ADDENDUM NO. 1

Hobcaw Education Center [NERR]: Dam Maintenance and Educational Water Control System Replacement

NOTICE TO ALL BIDDERS

SITE
PLAN

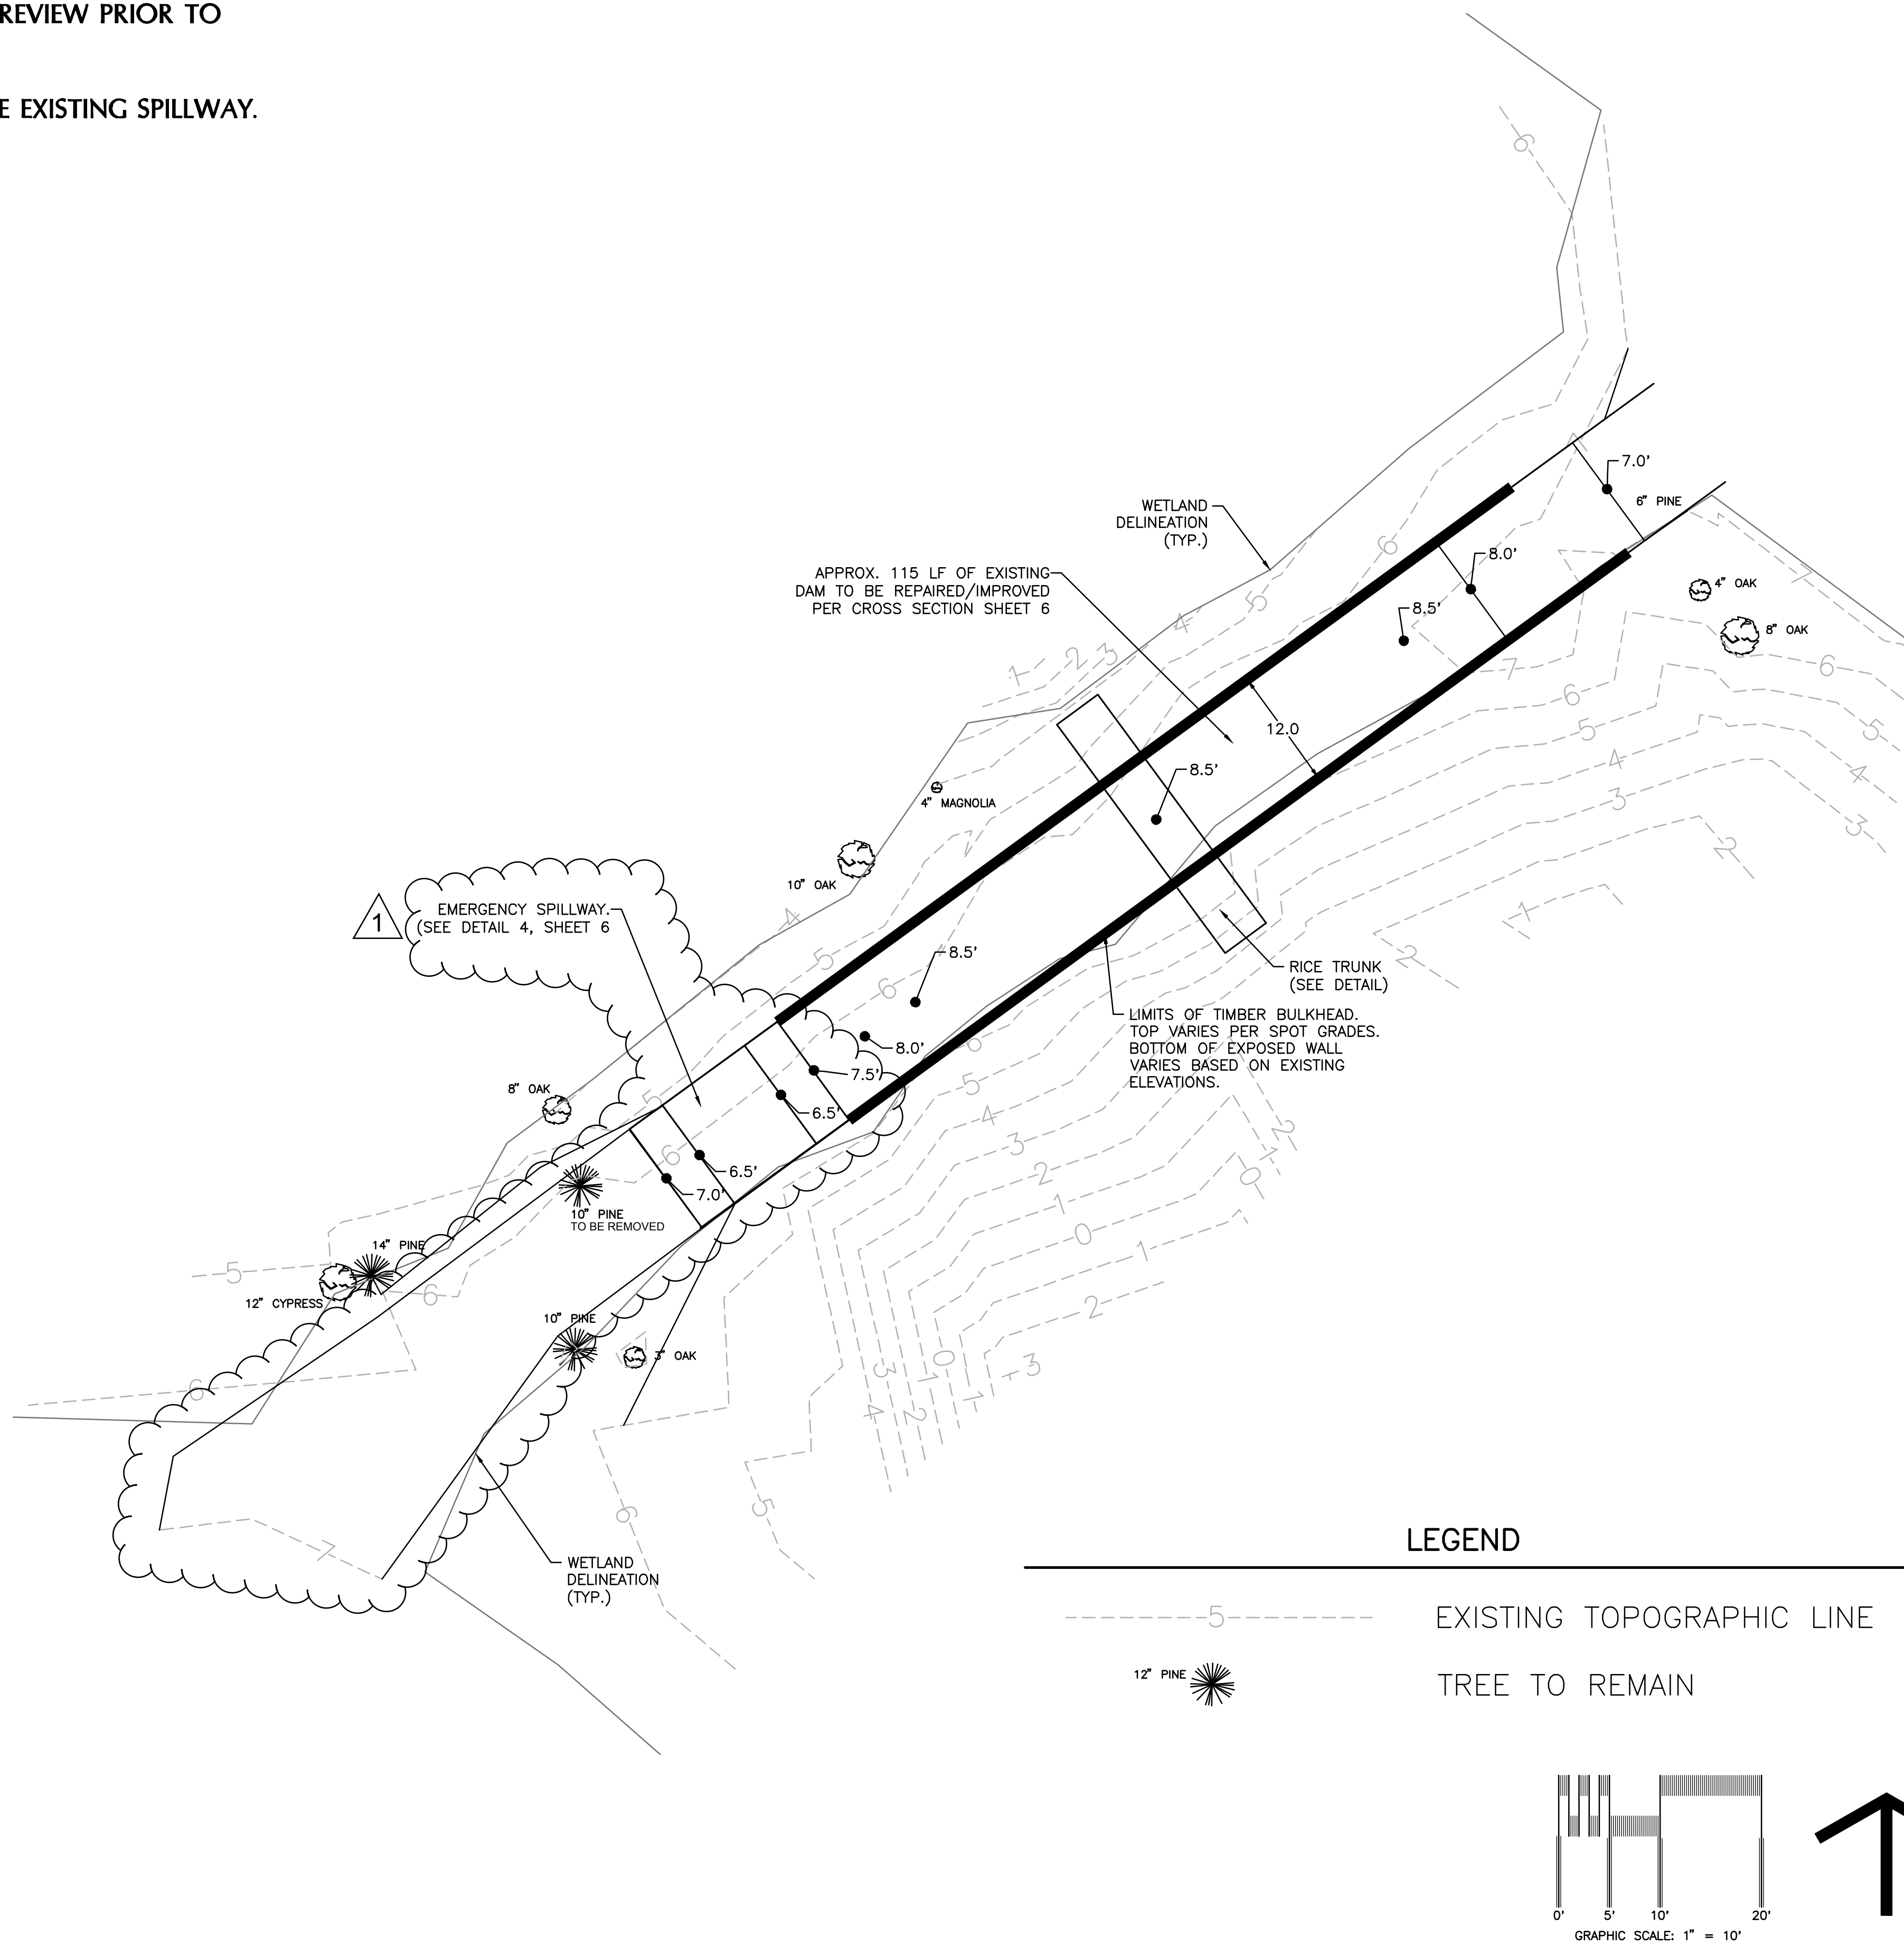
- Item 1-4. Sheet CIVIL-5 (5 of 6): Replace entire sheet with revised sheet CIVIL-5, included as an Attachment.
- Item 1-5. Sheet CIVIL-6 (6 of 6): Replace entire sheet with revised sheet CIVIL-6, included as an Attachment.
